APPLICATION NO.	FILING DATE	FIRST NAMED INVENTOR	ATTORNEY DOCKET NO.	CONFIRMATION NO.
10/631,817	08/01/2003	Pao-Hsien Cheng	MR957-1368	1719
4586	7590	12/16/2004	EXAMINER	
ROSENBERG, KLEIN & LEE 3458 ELLICOTT CENTER DRIVE-SUITE 101 ELLIOTT CITY, MD 21043			KLEBE, GERALD B	
			ART UNIT	PAPER NUMBER
			3618

Office Action Summary	Application No.	Applicant(s)
	10/631,817	CHENG ET AL.
	Examiner	Art Unit
	Gerald B. Klebe	3618

DETAILED ACTION

Fig. 1 PRIOR ART

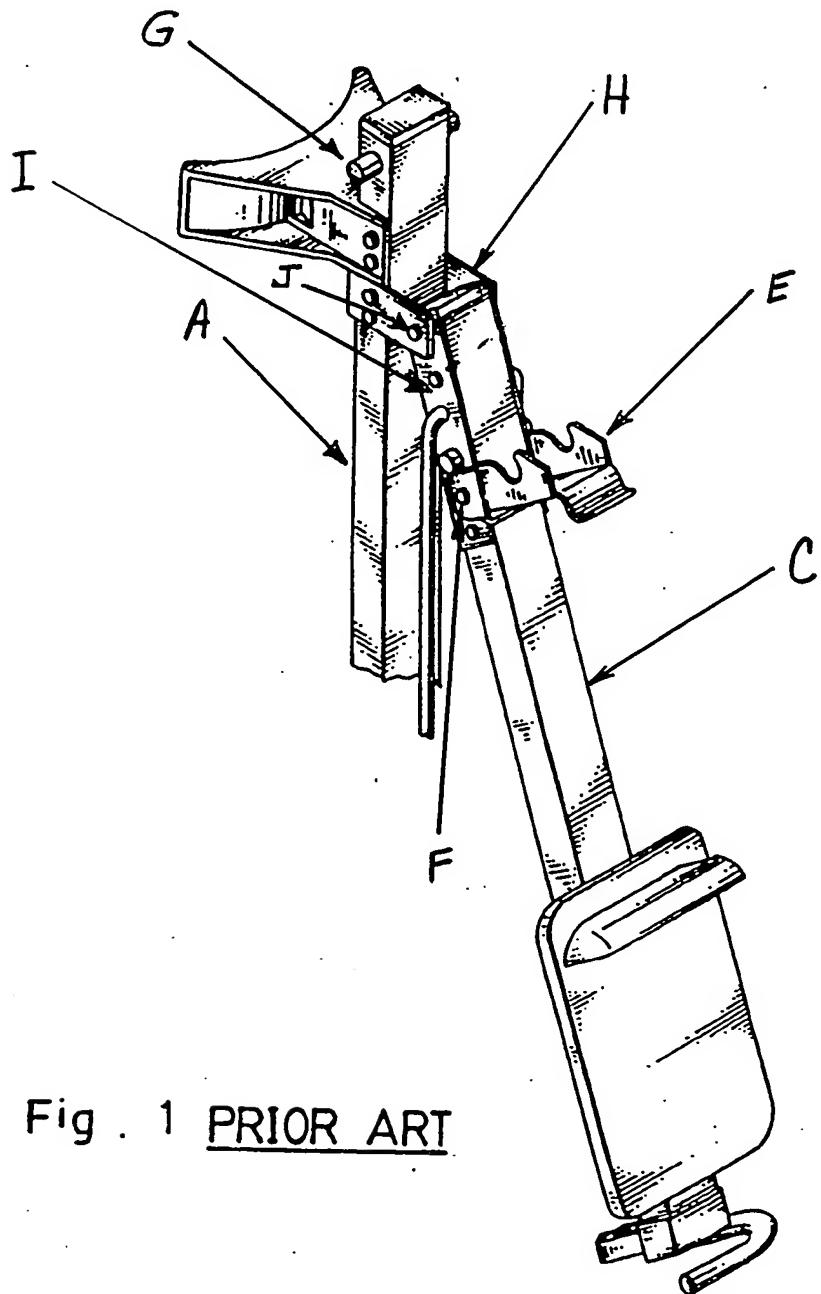
Wu teaches as old and well-known (refer Figs 1-3, and the examiner's mark-up of copies of these figures provided in explanation that are attached hereto) a foldable golf bag cart comprising:

a main support member (refer examiner's mark-up of Figs 1 and 2, item A) having two wheeled supports (B) pivotally coupled thereto; a handle rod (C) pivotally coupled to an upper end of the main support member at a lower end thereof; two co-moving rods (D) pivotally coupled to the handle rod at upper ends of the two co-moving rods, and pivotally coupled to respective ones of the wheeled supports (B) at lower ends of the two co-moving rods, the handle rod (C) having a fixing hook (E) pivotally coupled thereto by means of a pivotal element (F), the main support member having an engaging protrusion (G) thereon, the fixing hook being engageable with the engaging protrusion to prevent the handle rod from moving relative to the main support member when the golf bag cart is in a stretched position (shown in Fig 2), the handle rod (C) having a through hole, and the fixing hook having a through hole, the pivotal element (F) being passed through the through holes of the handle rod and the fixing hook; and,

a main support member (refer examiner's mark-up of Figs 1 and 2, item A) having two wheeled supports (B) pivotally coupled thereto;

a handle rod (C) pivotally coupled to an upper end of the main support member at a lower end thereof;

two co-moving rods (D) pivotally coupled to the handle rod at upper ends of the two co-moving rods, and pivotally coupled to respective ones of the wheeled supports (B) at lower ends of the two co-moving rods, the handle rod (C) having a fixing hook (E) pivotally coupled thereto by means of a pivotal element (F), the main support member having an engaging protrusion (G) thereon, the fixing hook being engageable with the engaging protrusion to

Fig. 2 PRIOR ART

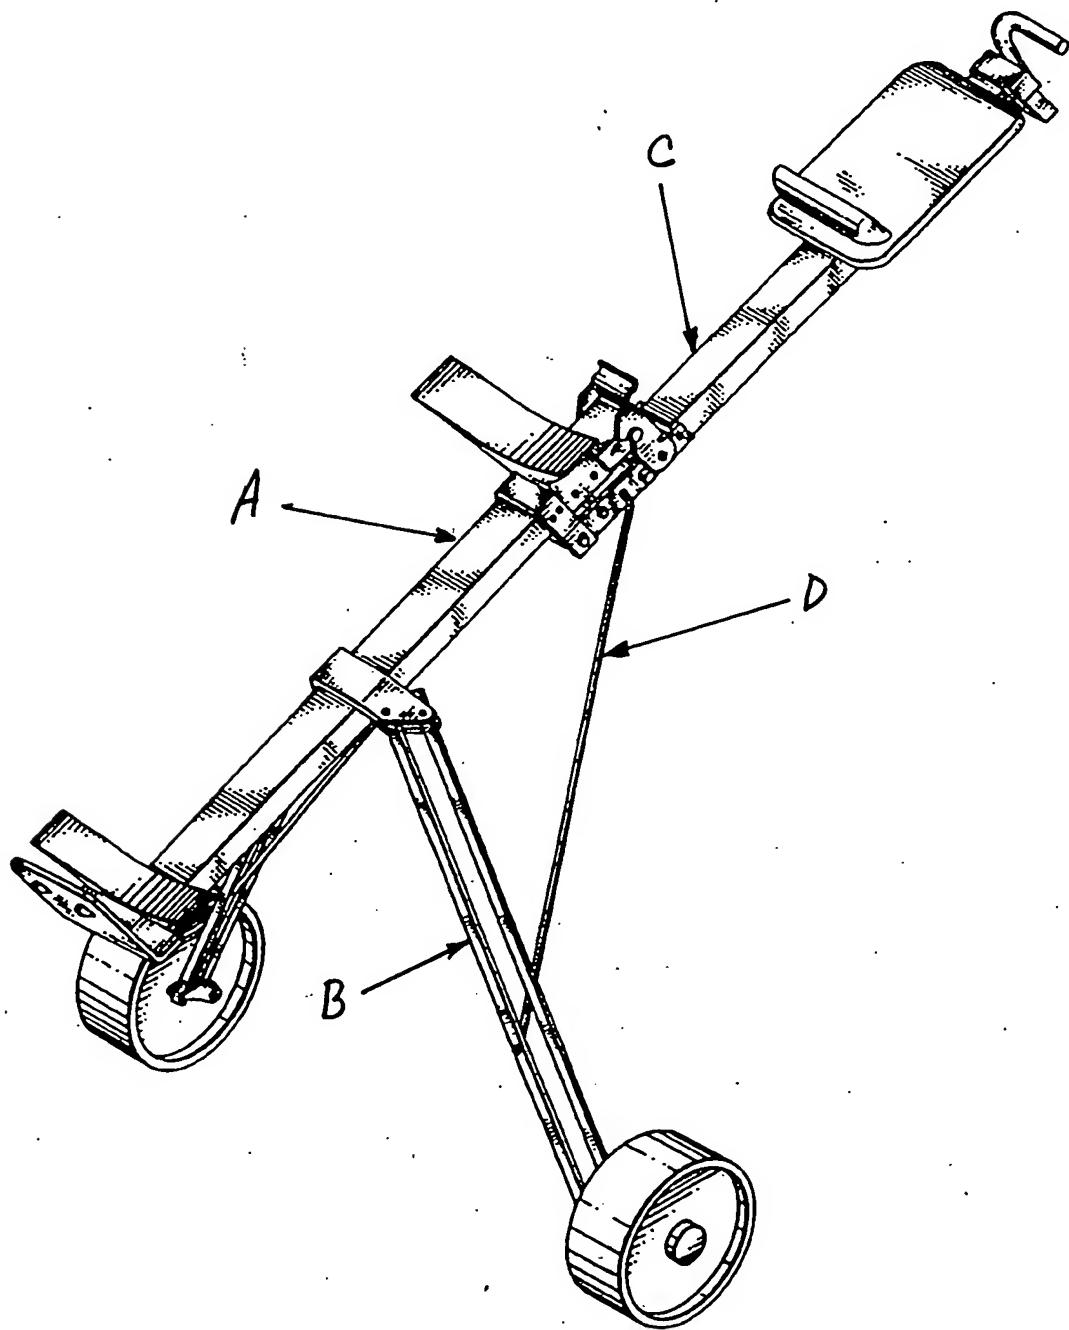
(re: claim 2) wherein the main support member has a plurality of connecting ears (H) with opposing pivotal hole formed therein, and the handle rod has a plurality of connecting ears (I) with opposing pivotal holes formed therein and a pivotal rod (J) passed through the opposing pivotal holes of the connecting ears of the main support member and the opposing pivotal holes of the connecting ears of the handle rod.

prevent the handle rod from moving relative to the main support member when the golf bag cart is in a stretched position (shown in Fig 2).

a main support member (refer examiner's mark-up of Figs 1 and 2, item A) having two wheeled supports (B) pivotally coupled thereto; a handle rod (C) pivotally coupled to an upper end of the main support member at a lower end thereof; two co-moving rods (D) pivotally coupled to the handle rod at upper ends of the two co-moving rods, and pivotally coupled to respective ones of the wheeled supports (B) at lower ends of the two co-moving rods, the handle rod (C) having a fixing hook (E) pivotally coupled thereto by means of a pivotal element (F), the main support member having an engaging protrusion (G) thereon, the fixing hook being engageable with the engaging protrusion to prevent the handle rod from moving relative to the main support member when the golf bag cart is in a stretched position (shown in Fig 2).
